CITY OF ALBUQUERQUE

RE: 621 James Ave NW
Grading and Drainage Plan
Engineer's Stamp Date: 5/22/25
Hydrology File: F14D088
Case # HYDR-2025-00190

Based upon the information provided in your submittal received 5/22/2025, the Grading plan is **approved** for Building Permit and Grading Permit. Please attach a copy of this approved plan in the construction sets for Building Permit processing along with a copy of this letter.

ENGINEER'S SEAL	LOT 14-B BLK 10 BELMONT PLACE ADD. 621 JAMES AVE. NW	DRAWN BY DEM
		DATE 5-22-25
	GRADING AND DRAINAGE PLAN	C1 James Ave NW-621.jpg
5/22/25	 <i>Rio Grande Engineering</i> PO BOX 93624 ALBUQUERQUE, NM 87199 (505) 321-8099	SHEET # C1
DAVID SOULE P.E. #14522		JOB # _____

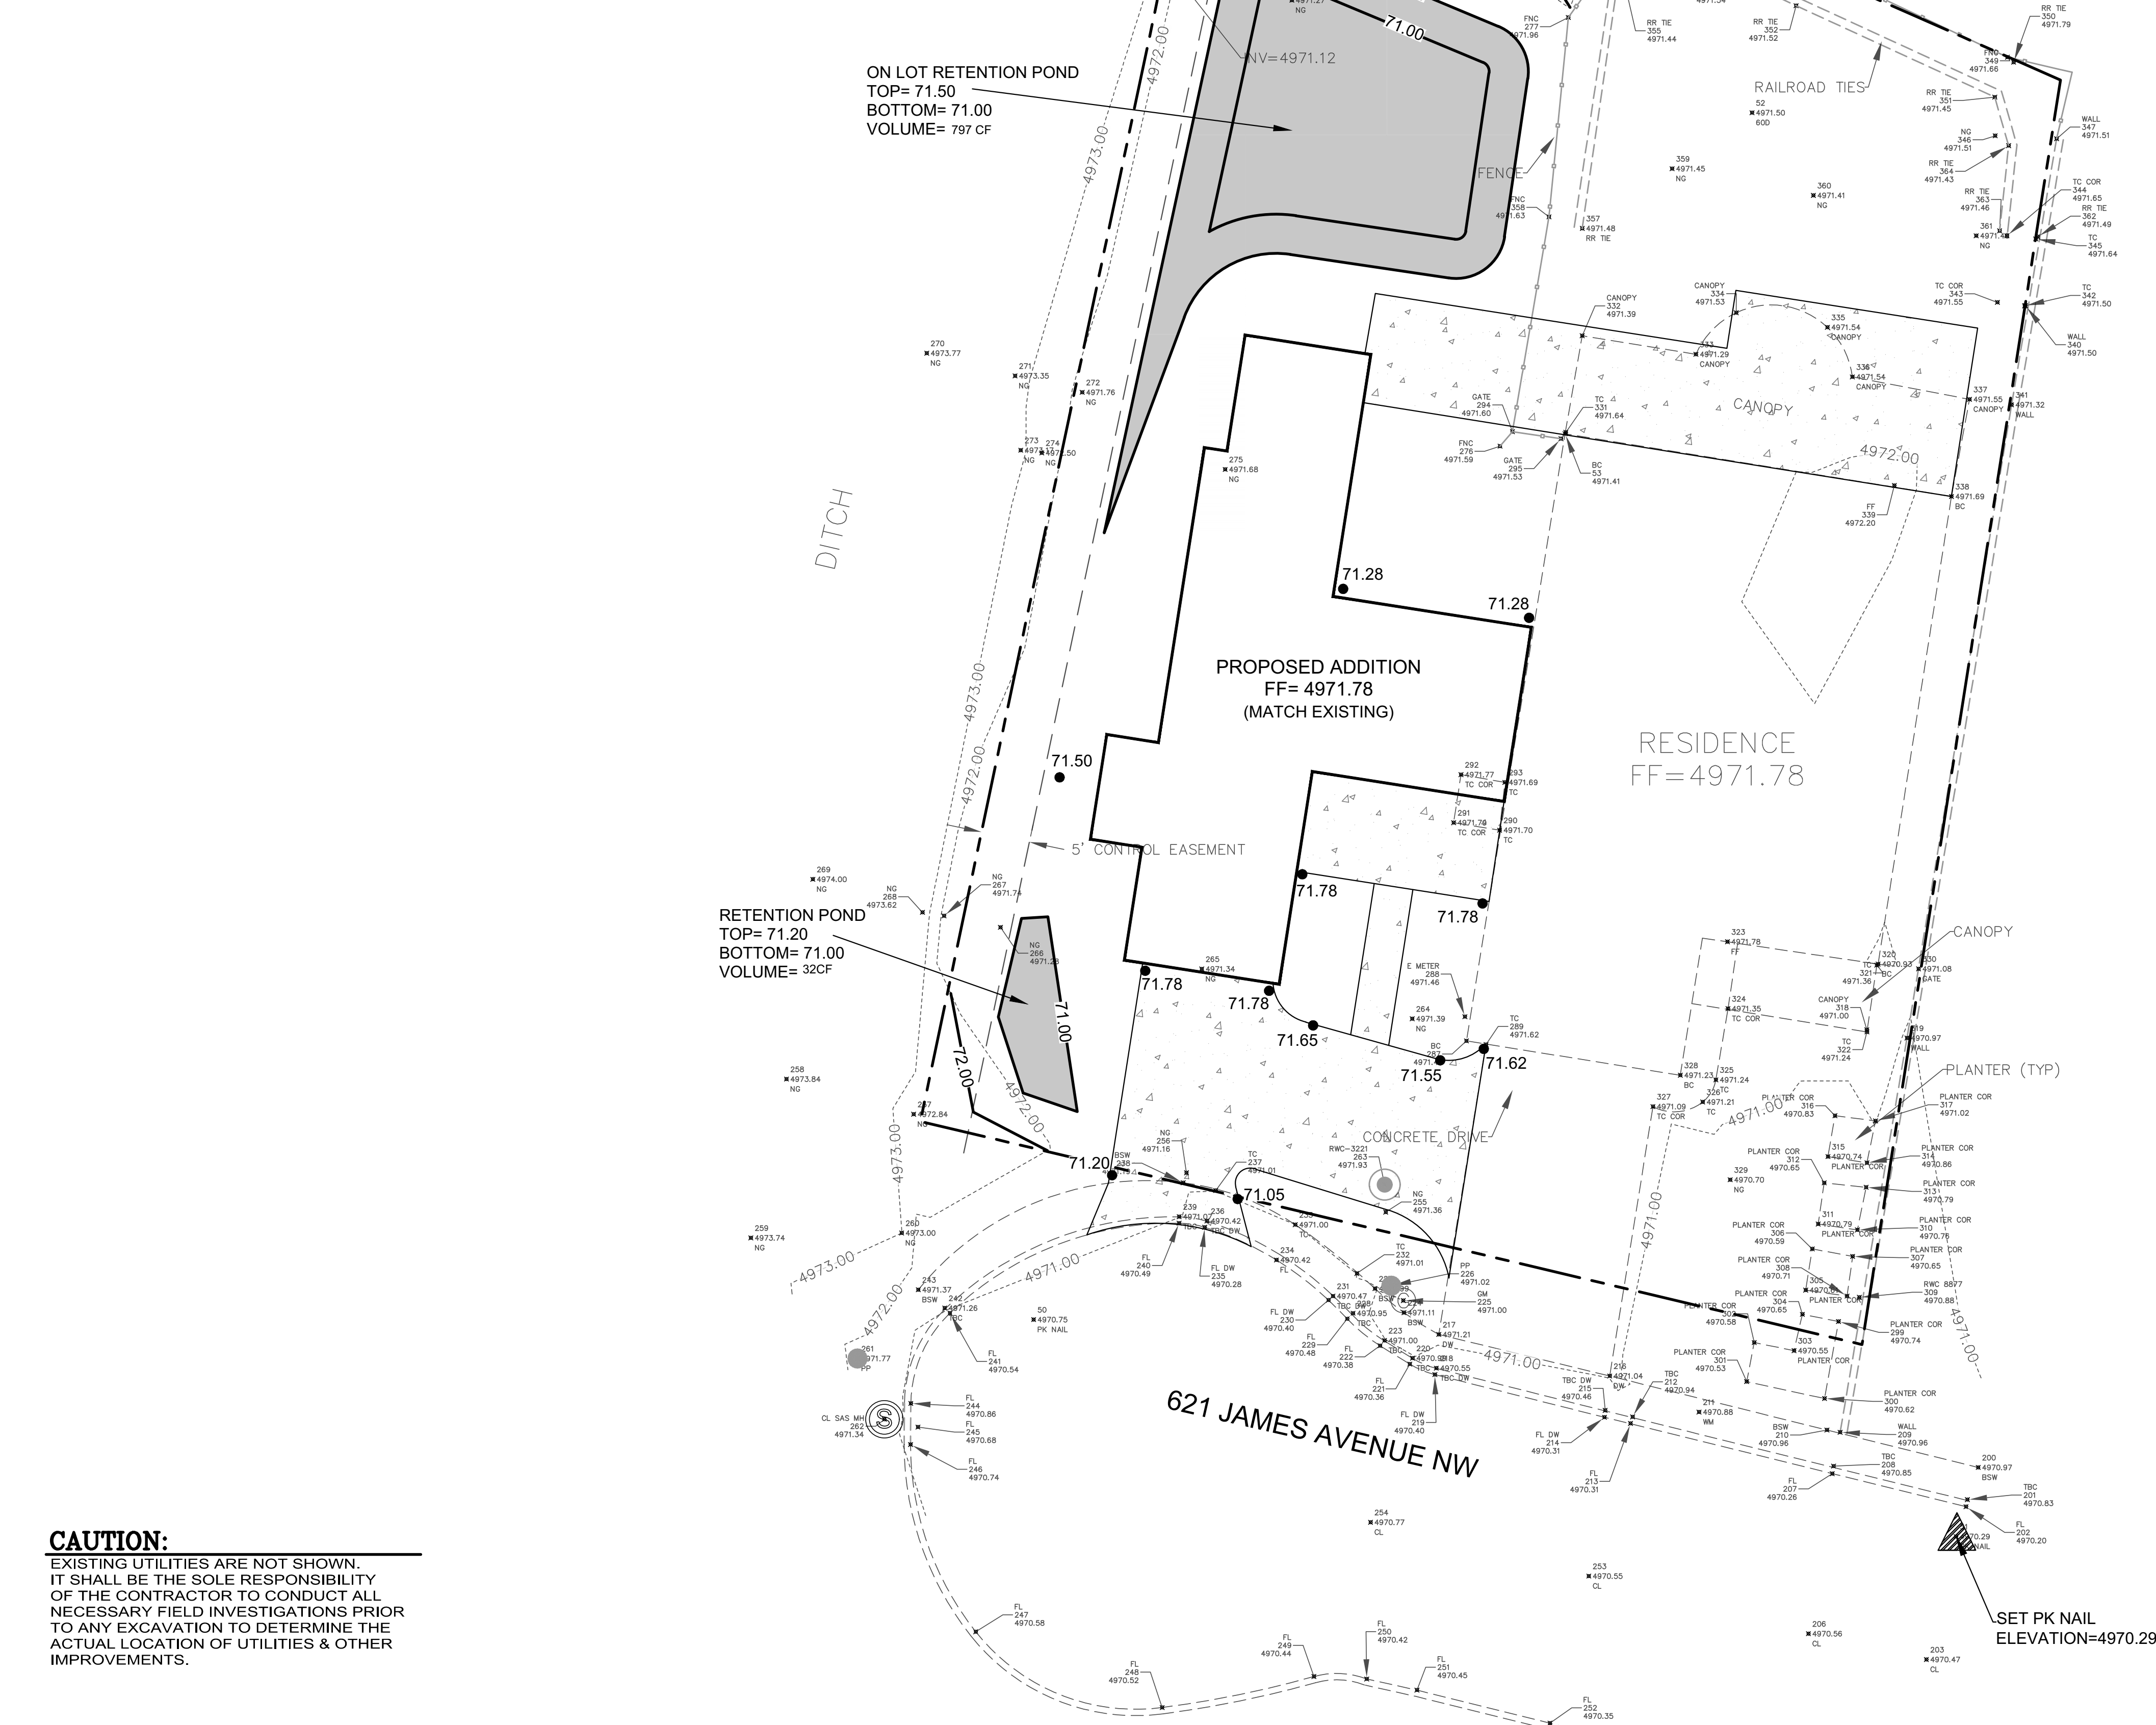
1. Engineer's Certification, per the DPM Part 6-14 (F): *Engineer's Certification Checklist For Non-Subdivision* is required.
